CENWS-OD-TS-DMMO

MEMORANDUM FOR: RECORD July 30, 2009

SUBJECT: DETERMINATION REGARDING THE SUITABILITY OF PROPOSED DREDGED MATERIAL FROM THE THATCHER BAY NEARSHORE RESTORATION PROJECT, BLAKELY ISLAND, SAN JUAN COUNTY, FOR UNCONFINED OPEN-WATER DISPOSAL AT THE ROSARIO STRAIT DISPERSIVE SITE.

Figure 2
Actual Core Locations and Prospective Dredge Areas
Thatcher Bay Site

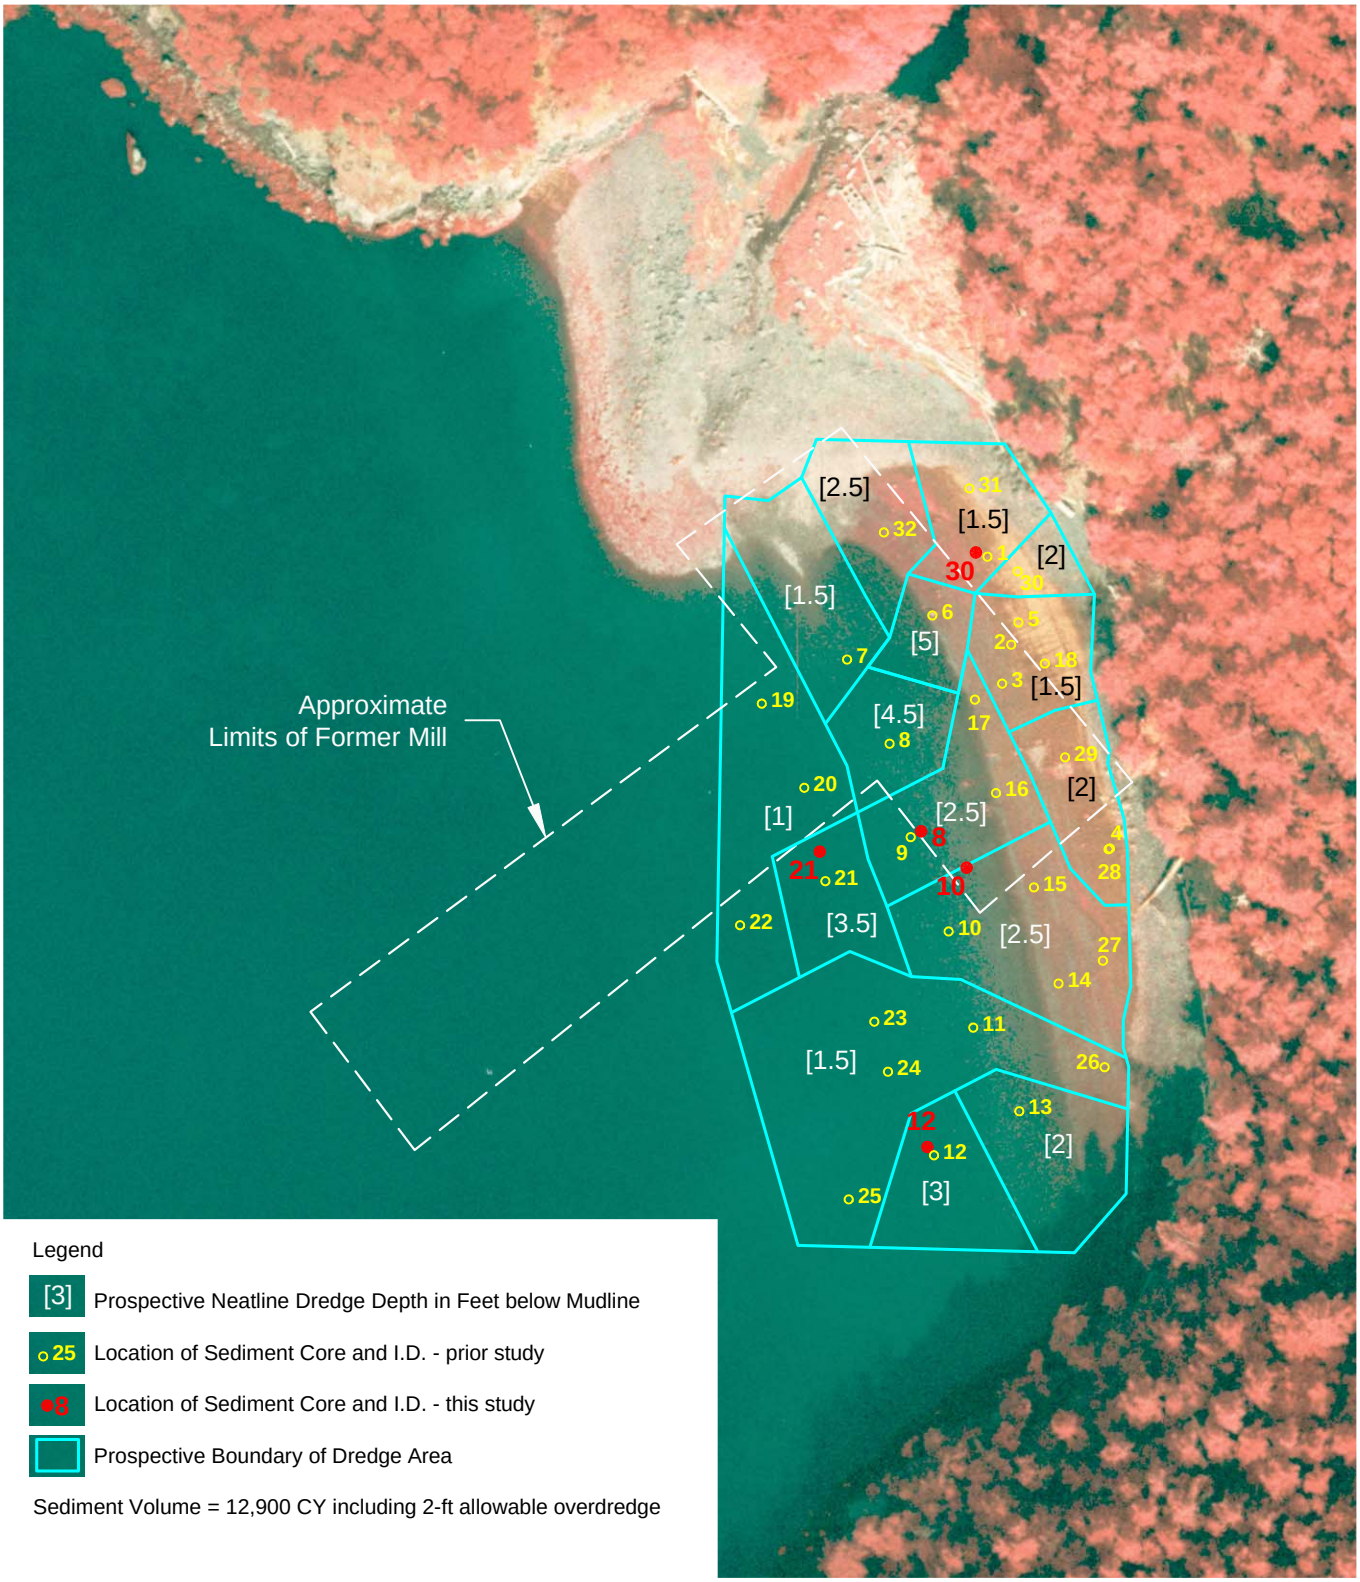
A subset of the sampling locations visited in the University of Washington study (UW, 2008) was selected for dredged material characterization (see Figure 2). The sampling plan called for penetration to a depth of three feet beyond the layer of mixed surficial woody debris/sediment at each location. This included two feet of overdepth plus a one-foot z-sample. The overdepth was to be included in the composited sample representing the DMMU, with the z-sample at each station collected and archived separately.

5. Sampling. Sampling took place April 27, 2009 using a vibracore. The vibracore encountered refusal at several sampling locations, primarily due to large woody debris. At these stations the vibracore was repositioned until penetration improved. However, at station 10, penetration beyond the wood waste may not have been achieved and, despite several attempts, full penetration could not be obtained at station 30 due to a layer of coarse sand overlying the wood waste. See Figure 2 for target and actual sampling locations and Table 2 for detailed sampling and compositing information.

Despite the problems encountered during sampling, the DMMP agencies determined that the collected samples adequately represent the proposed dredged material. The number of samples taken was well above the minimum requirement. While some sampling locations were moved to avoid large woody debris, there were two samples (10 and 30) that likely contained a disproportionate fraction of wood waste due to limited penetration. The samples were also fairly well distributed and were taken largely from areas with thicker layers of wood waste.
